UNITED STATES
DEPARTMENT OF THE INTERIOR
BUREAU OF LAND MANAGEMENTFORM APPROVED
OMB NO. 1004-0135
Expires: July 31, 2010**SUNDRY NOTICES AND REPORTS ON WELLS**
Do not use this form for proposals to drill or to re-enter an abandoned well. Use form 3160-3 (APD) for such proposals.**SUBMIT IN TRIPLICATE - Other instructions on reverse side.**

| 3b. Phone No. (include area code) Ph: 281-840-4266 | | 8. Well Name and No. SKELLY UNIT 072 |

NOTICE OF INTENT TO REPAIR CASING:

Conditions of Approval

Wellbore Schematic

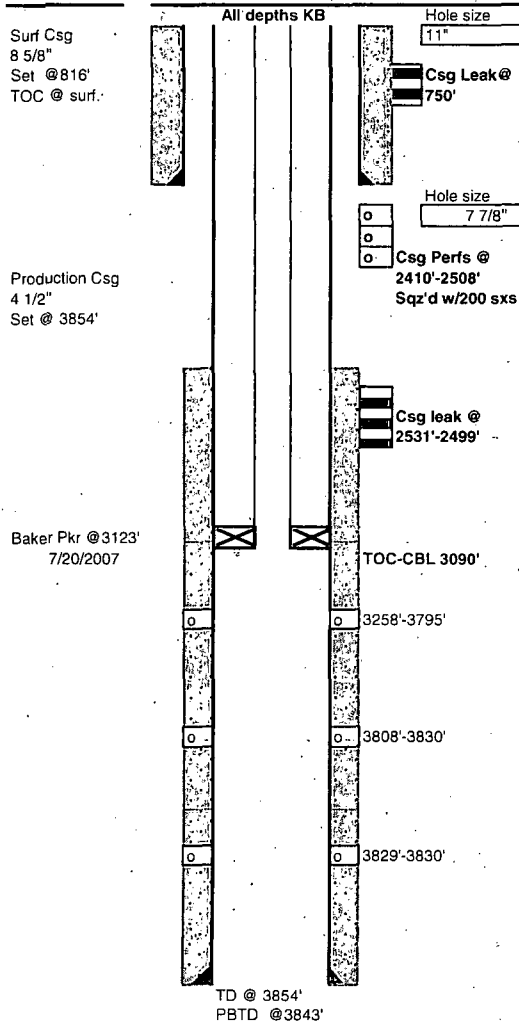
LINN PROPOSES TO MIRU, PULL UP THE HOLE TO APPROXIMATELY 60' W/TUBING & PACKER AND RESET.

REPAIR HOLE IN CASING BY WELDING HOLE IN SURFACE/PRODUCTION CASING.

RIH W/TBG & PKR TO ORIGINAL DEPTH OF 3123'

CONTACT BLM TO WITNESS MIT TEST.

4. Provide BLM with an electronic copy (Adobe Acrobat Document) cement bond log record from 3200 or below to top of cement. The CBL may be attached to an email to pswartz@blm.gov

- 1) Conduct a Mechanical Integrity Test of the tubing/casing annulus after a tubing, packer or casing seal is established. Repair that seal any time more than five barrels of packer fluid is replaced within 30 days.

- 2) The minimum test pressure should be 500 psig for 30 minutes or 300 psig for 60 minutes, with 200 psig differentials between tubing and casing pressure (at test time) but no more than 70% of casing burst pressure as described by Onshore Order 2.III.B.1.h. (The tubing or reservoir pressure may need to be reduced). An alternate method for a BLM approved MIT is to have the fluid filled system open to atmospheric pressure and have a loss of less than five barrels in 30 days witnessed by a BLM authorized officer.
